| marantz® SERVICE BULLETIN | | Date: 31-Oct.-2003 | Model: SR4300/SR4400 |
| | | Page: 1 / 3 | REF.NBR: MZ03-047 |
| Application: | | The problem of the Speaker protection circuit. | |

SR4300

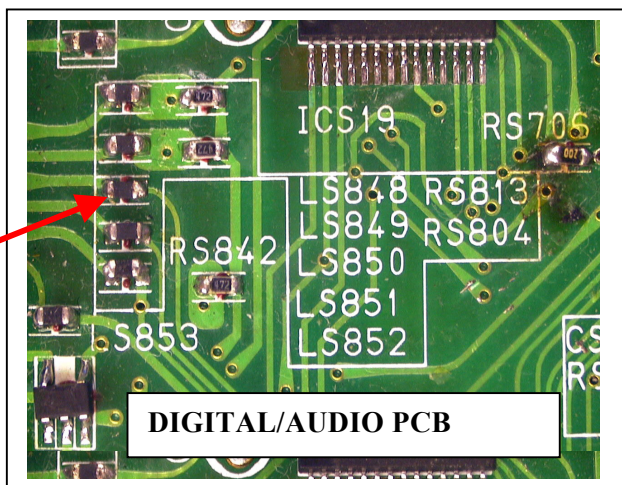
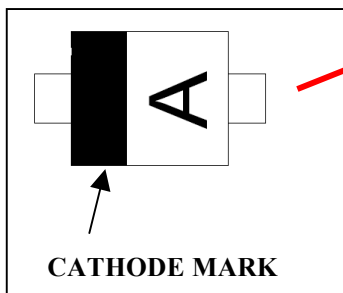
LS850 is changed to
Part no. *HD201810R

Caution
JFS08 (FPC CONNECTOR) side is
CATHODE

Adhesives:
SC608LVZ (Sony Chemical Corp. – Self-extinguishing adhesive) or the equivalent

- 1) Chip Resistor **LS850** (100 ohm 1/16W part no. NN05101610) is changed to **Silicon Diode (Part no. *HD201810R--- 1SS400 POHM: EMD2, EIAJ: SC-79, JEDEC: SOD-523)**.

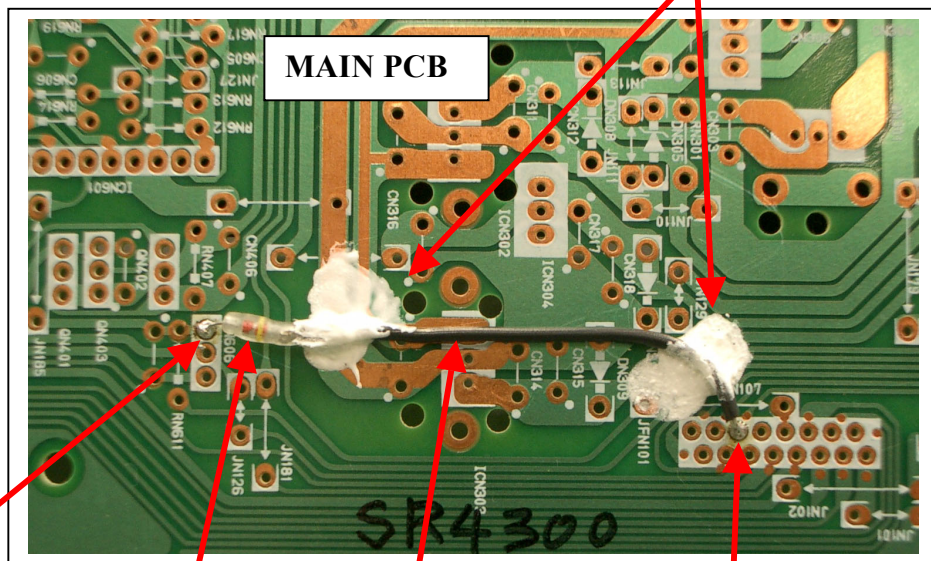
BASE of QN606

No.5 pin of JFN101

DN601
Part no. HD20002000

Insulation tube is used

- 2) Chip Resistor **DN601(Part no.HD20002000---Silicon Diode 1SS254 ROHM)** is added between BASE of QN606 SEMICOM.COMP and No.5 pin of JFN101 Connector

SR4400

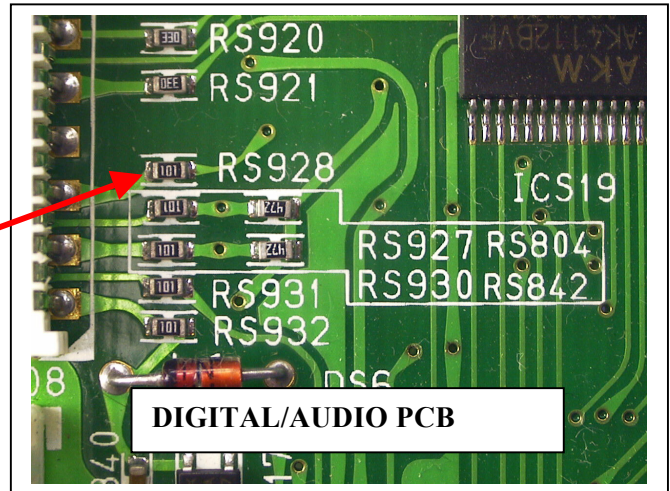
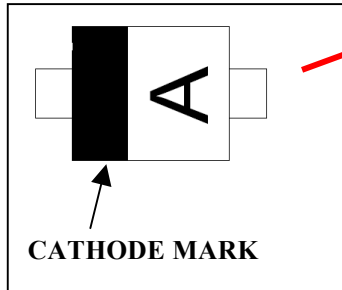
RS928 is changed to
Part no. *HD201810R

Caution
JFS08 (FPC CONNECTOR) side is
CATHODE

Adhesives:
SC608LVZ (Sony Chemical Corp. – Self-extinguishing adhesive) or the equivalent

BASE of QN606

No.5 pin of JFN101

Insulation tube is used

DN601
Part no. HD20002000

- 1) Chip Resistor **RS928** (100 ohm 1/16W part no. NN05101610) is changed to **Silicon Diode (Part no. *HD201810R--- 1SS400 POHM: EMD2, EIAJ: SC-79, JEDEC: SOD-523)**.

- 2) Chip Resistor **DN601(Part no.HD20002000---Silicon Diode 1SS254 ROHM)** is added between BASE of QN606 SEMICOM.COMP and No.5 pin of JFN101 Connector

Fig.2

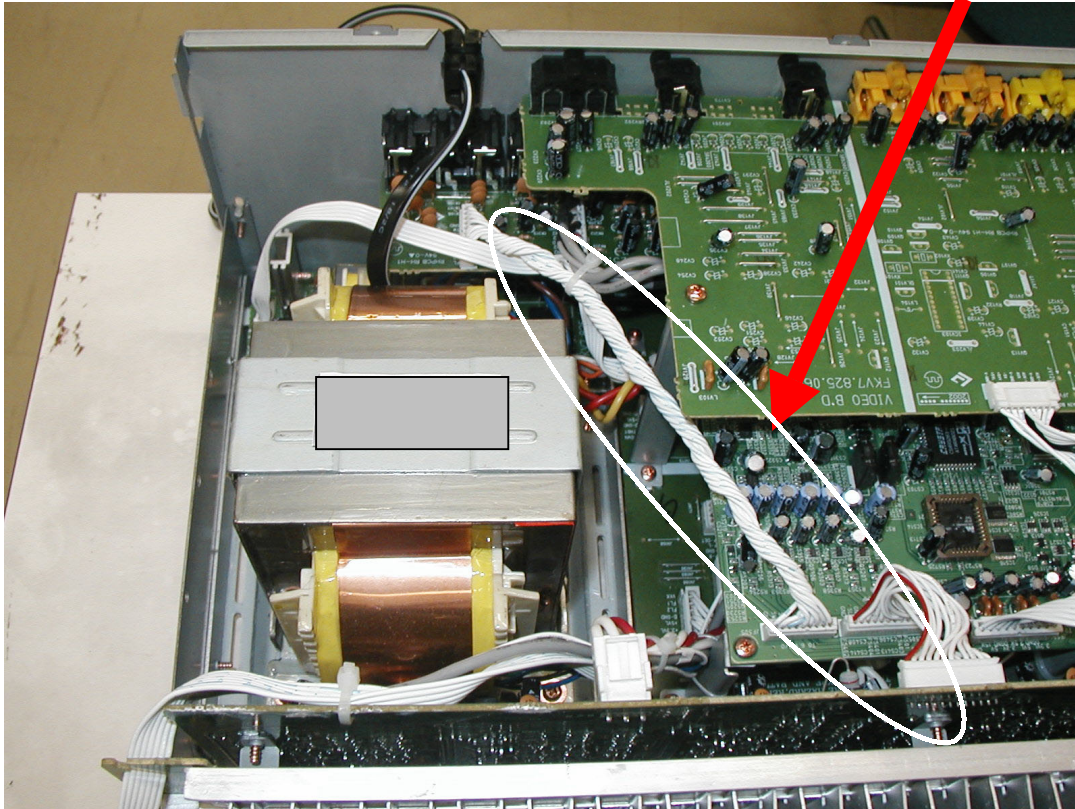
3. Cut a pattern. (please see Fig.1)
 4. Add a wire. (please see Fig.1)
 5. Twist the wire 5 times. (please see Fig.2)
- The 9pin wires are connected to JFS05(DIGITAL/AUDIO PCB) from JFK1(6.1CH/PRE OUT PCB)

Twist the wire 5 times

RS870 is this side of DIDITAL/AUDIO PCB

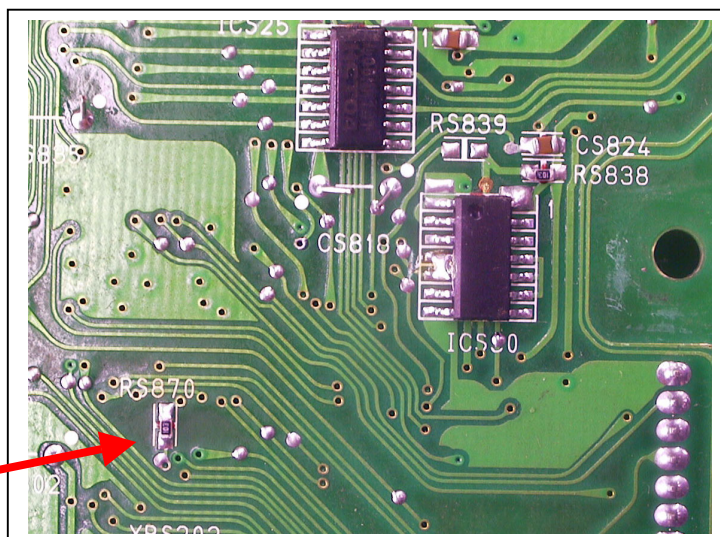
When the unit warms up, CPU clock stops, and the unit becomes a perfect stop.
The capacitor (0.1uF) was mounted instead of resistor RS870(10 k ohm) .
(When the PCB is repaired, it has the possibility that a capacitor (0.1uF) was used.)

RS870 (10 k ohm)

1. Confirm whether **RS870** on DIGITAL/AUDIO PCB is **10 k ohm Chip resistor**.
2. The part which isn't right, changed to **10 k ohm Chip resistor (Part no. NN05103610)**.

ICS14

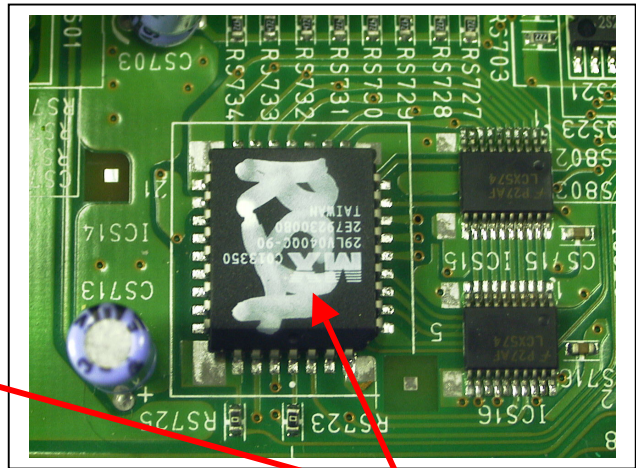
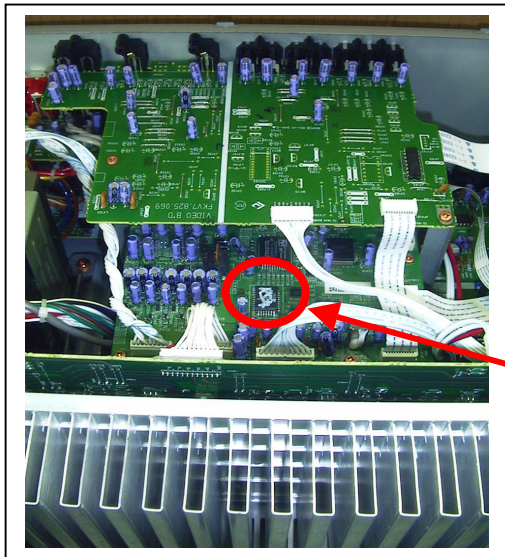
POS.NO ICS14 Part no. *HS09AWX2R MX29LV040QC-90 **Factory part no. OICMX29LV040QC90**
 [OLD part no. *HS09AWX0R Factory part no. OICMX29LV040QC90]

Replace IC (ICS14) on the **DIGITAL/AUDIO CIRCUIT BOARD**.
